PROPOSED ALDI DISCOUNT FOODSTORE AND COFFEE DRIVE-THROUGH WITH EV CHARGING HUB, LONDON ROAD, DEVIZES

TECHNICAL NOTE 02 REV B

21ST AUGUST 2026

Appendix 1 – Revised Highway Drawing

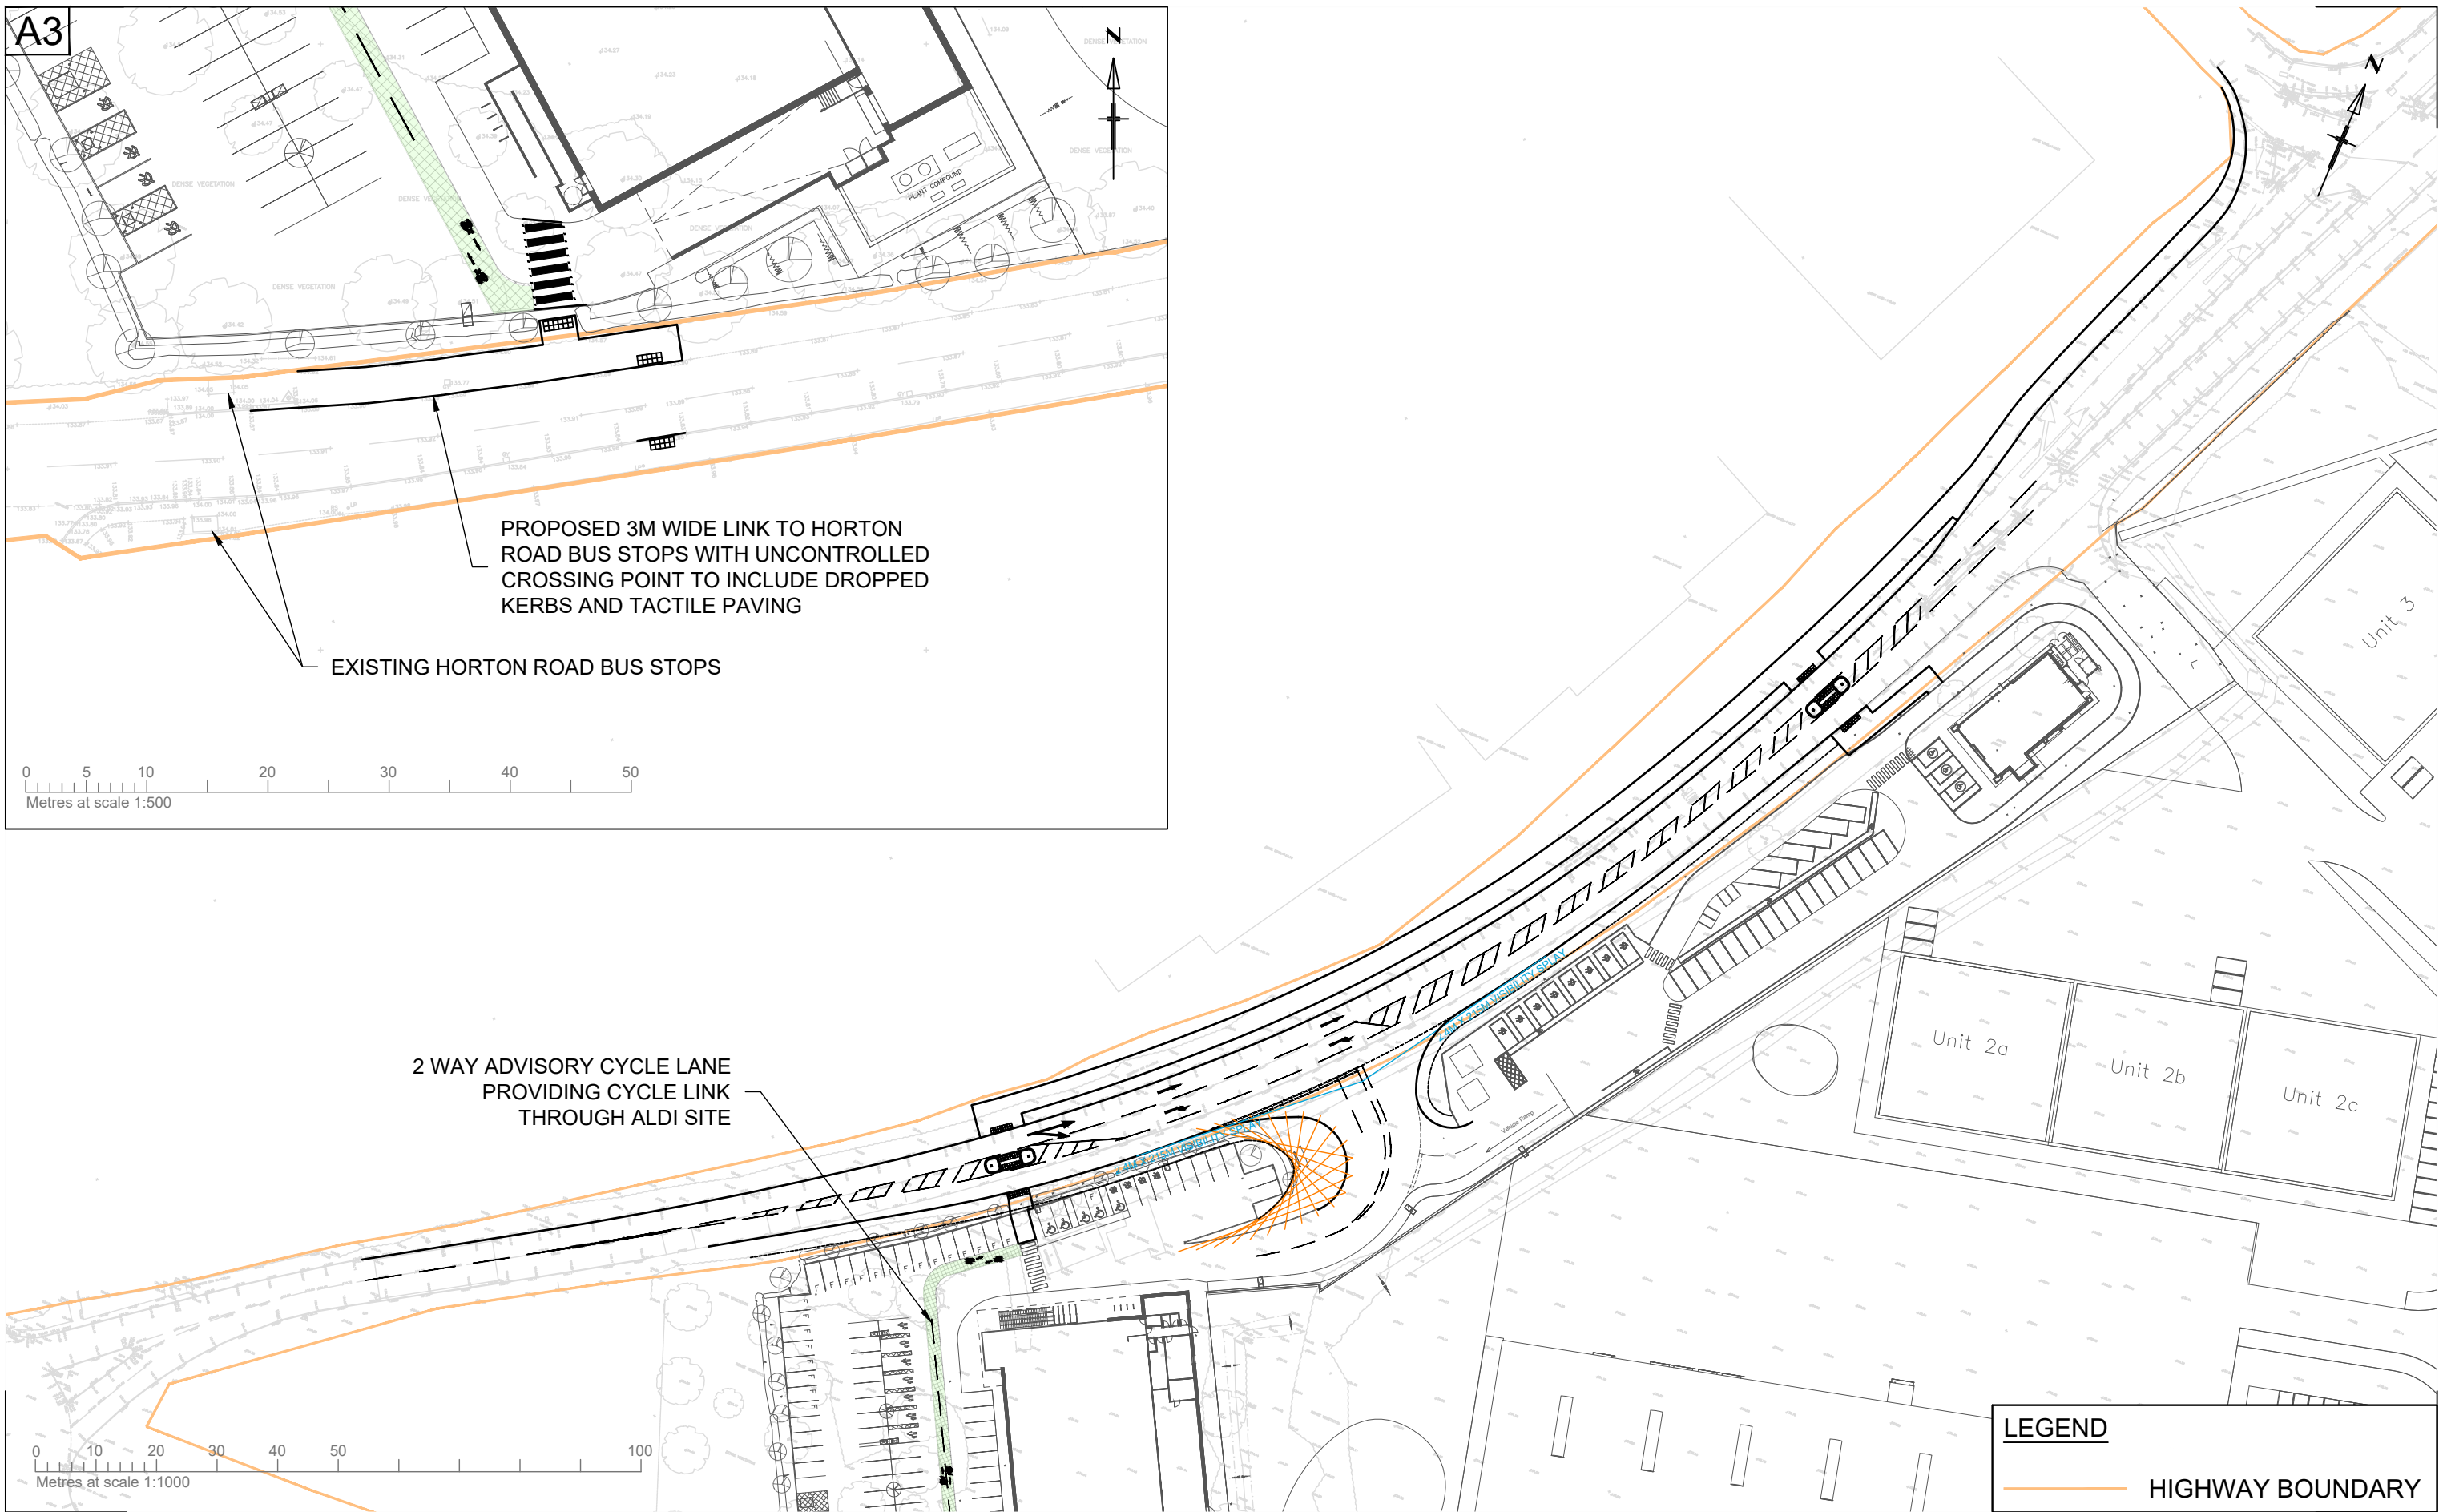
- 2.13 *Therefore, I insist that the applicant changes the southernmost crossing point into a TOUCAN crossing. Details of which should be provided for approval, including forward visibility and assessment of impact on vehicle movements."*

- 2.21 *"Pedestrian Provision through the site"*
- 2.22 *"I am still not happy with the internal path arrangement. The internal paths must be a minimum of 3m in width, this has been previously requested and not yet shown. It is also imperative that pedestrians and cyclists have a recognised presence in the circulation of the site and expecting them to share a 1.8m path hemmed in between the site boundary and the store is not acceptable. It is also not ideal to have a path with defined 90 degrees bends. As such I ask the applicant to provide a defined dedicated routh through the front of the store for pedestrians and cyclists. This can be in the form of lining/change of colour surface but must be prominent in its environment."*

- 2.23 *"Where the path enters the site at crossing point (between parking bays) the path must maintain its 3m width and be defined on the ground. (a buffer of at least 0.5m either side should be provided, between car parking spaces and path). This is the same for the path at the coffee shop site, which currently appears to reduce form 3m to 2m. The path must be a consistent 3m with a defined route into the site."*

- 2.26 If it would alleviate WC's concerns for cyclists travelling through this section, then cycle a route could potentially be marked through the car park, perhaps similar to two advisory cycle lanes (one for each direction) along the centre of the aisle closest to the building and indicated by the coloured zones that have been added to the drawings included at Appendix 1. We welcome WC's thoughts on this feature.

- 2.27 The revised layout also includes widening of the path to 3m between the parking spaces from the Aldi to London Road, and also to 3m along the proposed route from London Road to the (outline) coffee shop site.
